Replies to Referee #2

Regionalization of hydrological model parameters using gradient boosting machine

Zhihong Song, Jun Xia, Gangsheng Wang, Dunxian She, Chen Hu, Si Hong

Figure R1. Comparison of model performance in runoff (a: KGE, and b: PBIAS) and ET (c: KGE, and d: PBIAS) simulation between DTVGM and DTVGM-PML in the calibration and validation periods. KGE denotes the Kling-Gupta efficiency. PBIAS denotes the percent bias".

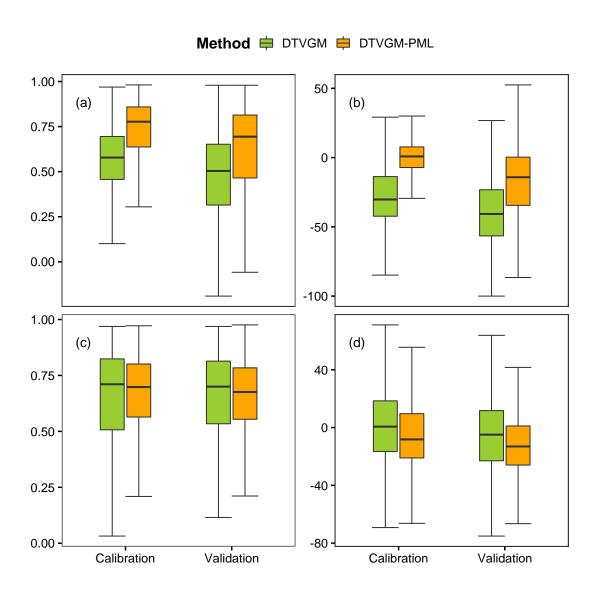
(3) Also in Figure 5, it would be helpful to show the comparison of the model performance with and without the PML addition so that one can see in quantifiable terms how the addition of the equation improves the calibration and validation performance.

Response: Thanks for the valuable suggestion! We will show the comparison of model performance with and without PML addition in Supplementary Fig. S2 (see Fig. R1). We will also add the following text to describe the results:

"A great deal of previous studies have highlighted the importance of incorporating the vegetation change information into hydrological models to achieve better performance in hydrological simulations (Donohue et al., 2007, 2010; Gerten, 2013; Ivanov et al., 2008; Lei et al., 2014; Thompson et al., 2011). And it has been demonstrated that the PML equation can improve the hydrological simulations under vegetation greening conditions by coupled into hydrological models (Bai et al., 2018; Li et al., 2009; Zhang et al., 2009; Zhou et al., 2013). We also performed the comparison of model performance in hydrological simulation between the original DTVGM (without PML) and DTVGM-PML. As shown in Figure R1, the KGE and PBIAS values of runoff simulation (Fig. R1a, b) based on DTVGM were lower than those from DTVGM-PML. The median KGE and PBIAS values of ET simulation (Fig. R1c, d) were comparable between the two models. However, the lower minimum values in the

boxplots (Fig. R1c, d) indicated DTVGM might produce worse performance (i.e., KGE < 0) than DTVGM-PML. Consequently, DTVGM-PML can help to improve hydrological simulation relative to DTVGM. Additionally, the consideration of vegetation dynamics by the PML equation would improve the mechanistic understanding of hydrological response under vegetation greening, which is lacking in DTVGM."

Figure R2. Taylor skill scores (TSS) of each parameter generated from the multiple linear regression (MLR) and the gradient boosting machine (GBM). The Taylor skill scores were computed using parameters from all grid cells across China.

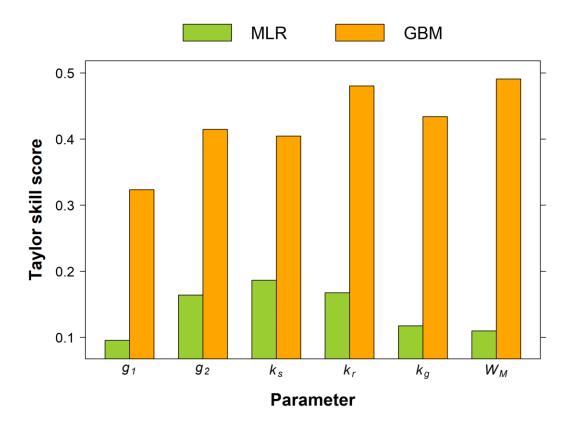
(4) Section 2.4: You provide an excellent description of the evaluation criteria; however, in your use of the Taylor skill score, could you clarify how the skill is determined for model parameters when you cannot know the true value of the parameters? L207-209 were somewhat confusing. This could be my lack of familiarity with the TSS, but it may be helpful to look over those lines to see if you could improve the explanation there.

Response: Thanks for your comments. We will provide more detailed information of the Taylor skill score (TSS) in the revised paper as follows:

In this study, we used the grid-scale calibrated parameters as the reference parameters to evaluate the regionalization model performance for estimating each parameter at each grid with TSS. We compared two regionalization methods, the gradient boosting machine (GBM) and the multiple linear regression (MLR). As shown

in Figure R2, GBM obviously outperformed MLR with a higher TSS, suggesting that the GBM-regionalized parameters presented a higher spatial agreement with reference parameter values than the MLR-generated parameters."
